ADDENDUM #2

NOTICE TO ALL BIDDERS FOR
CITY OF WINCHESTER

ITB #202005 – Valley Avenue Improvements

Water & Sanitary Sewer Relocation Plan

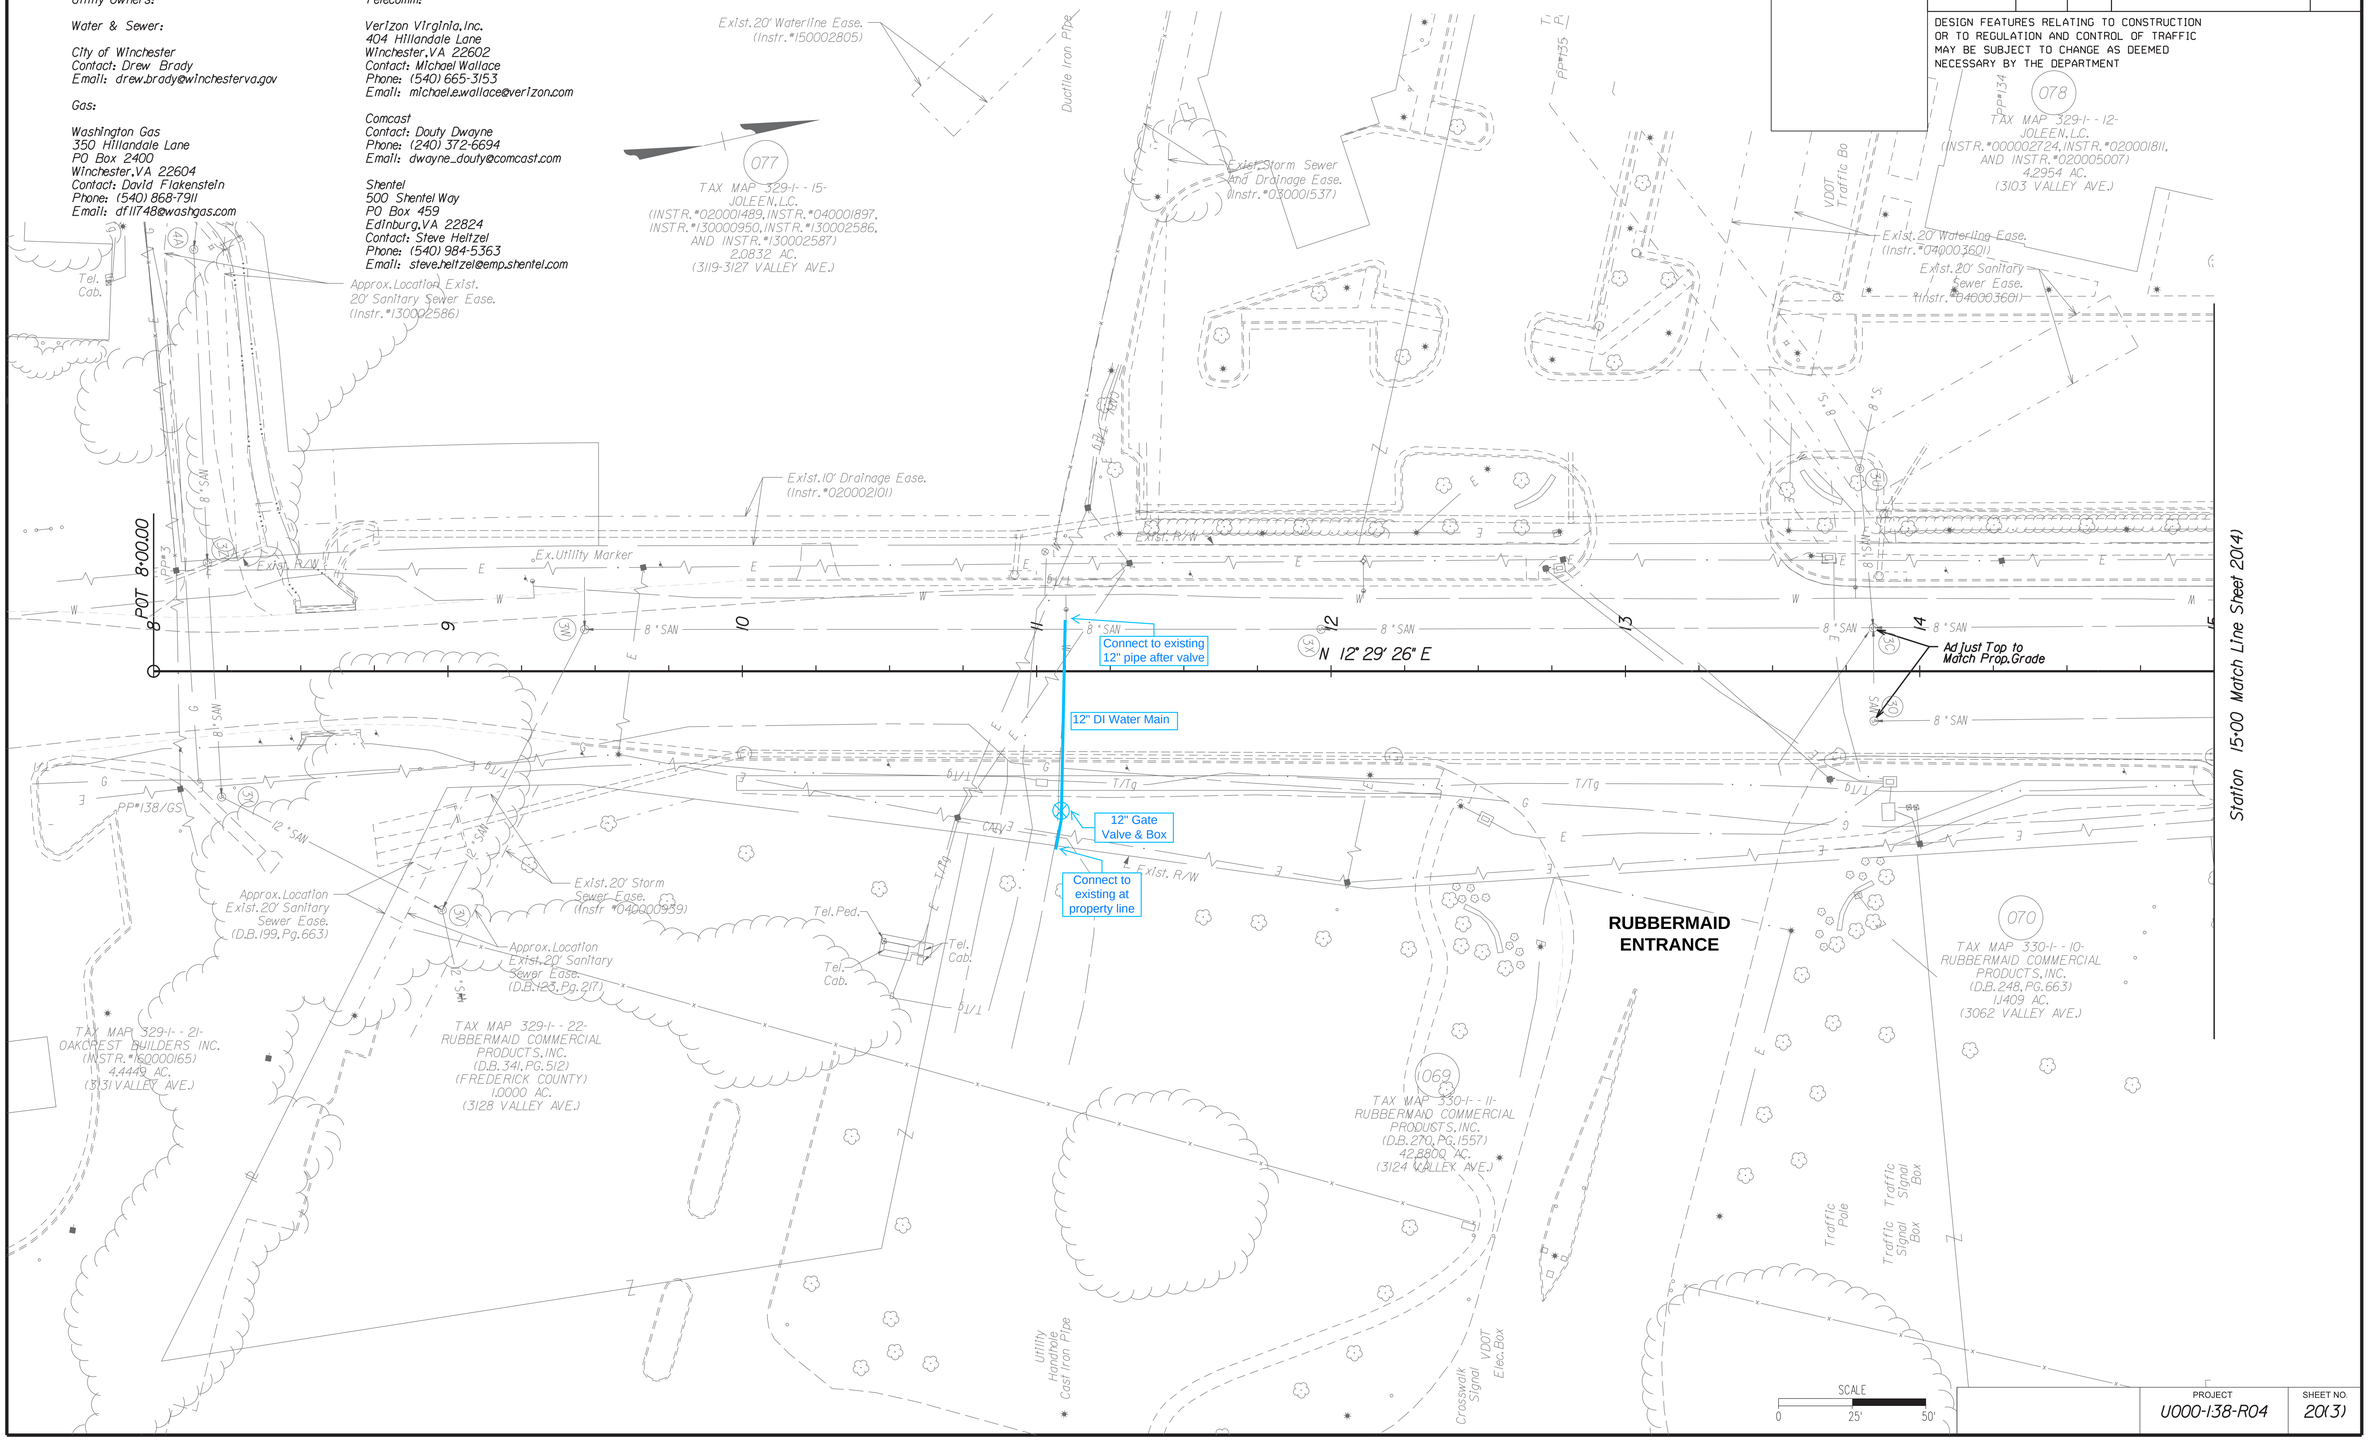
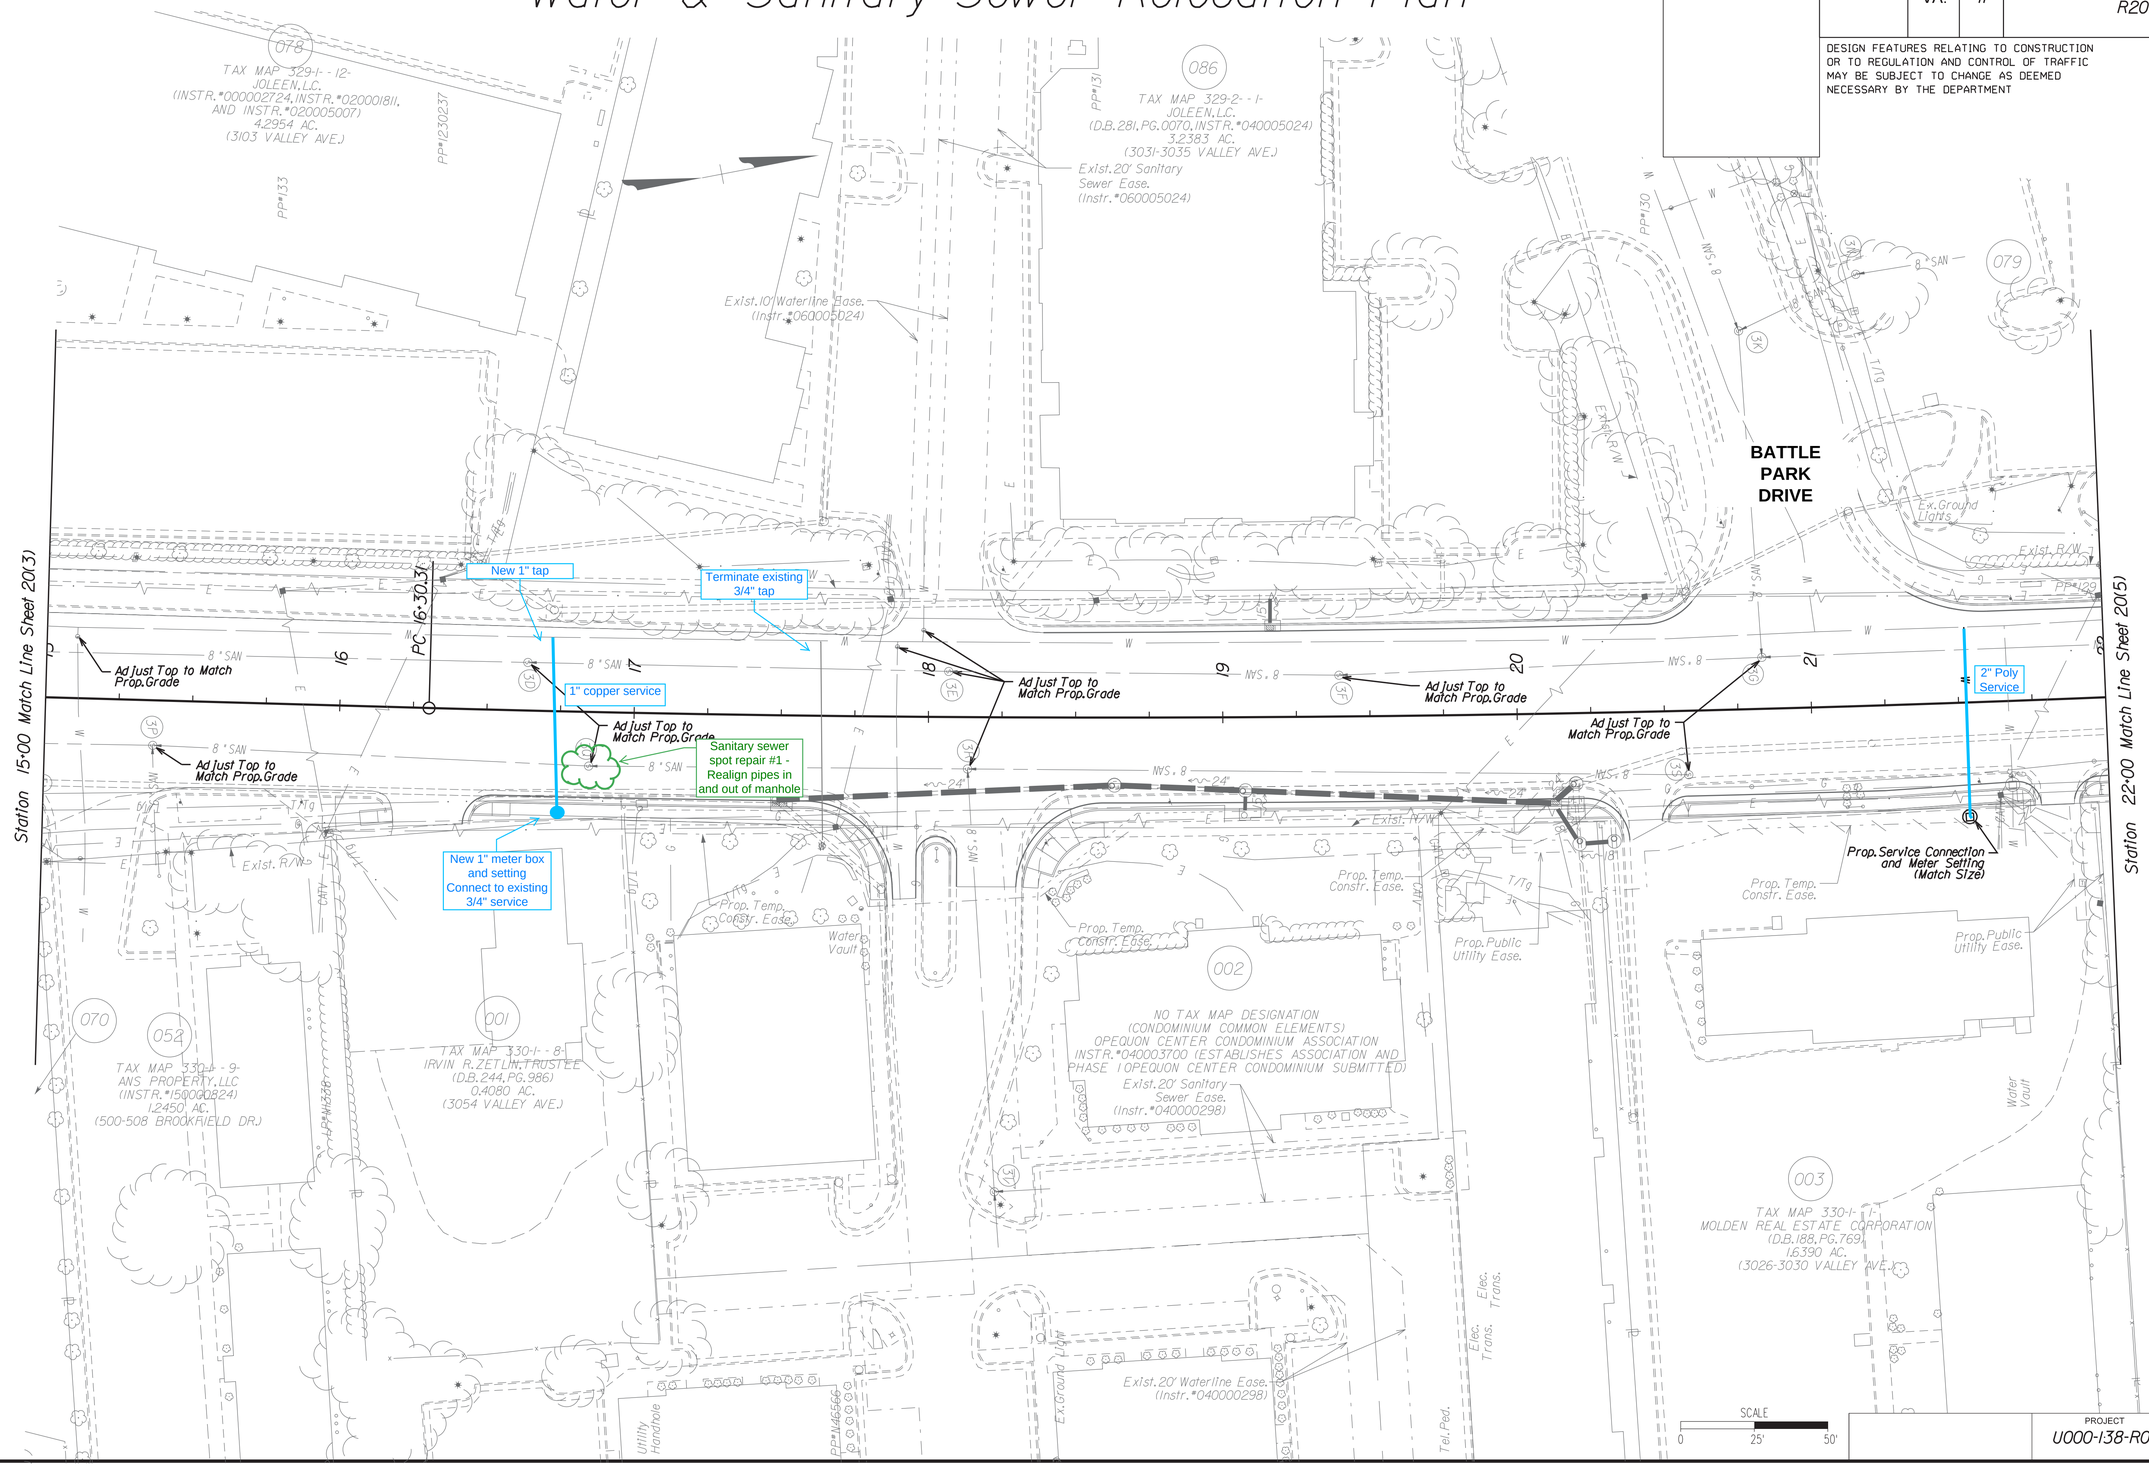
6. There have been numerous additions made to the water and sewer replacements for this project that are included in the revised Bid Form. The original plans have been modified with color showing this information and are attached.
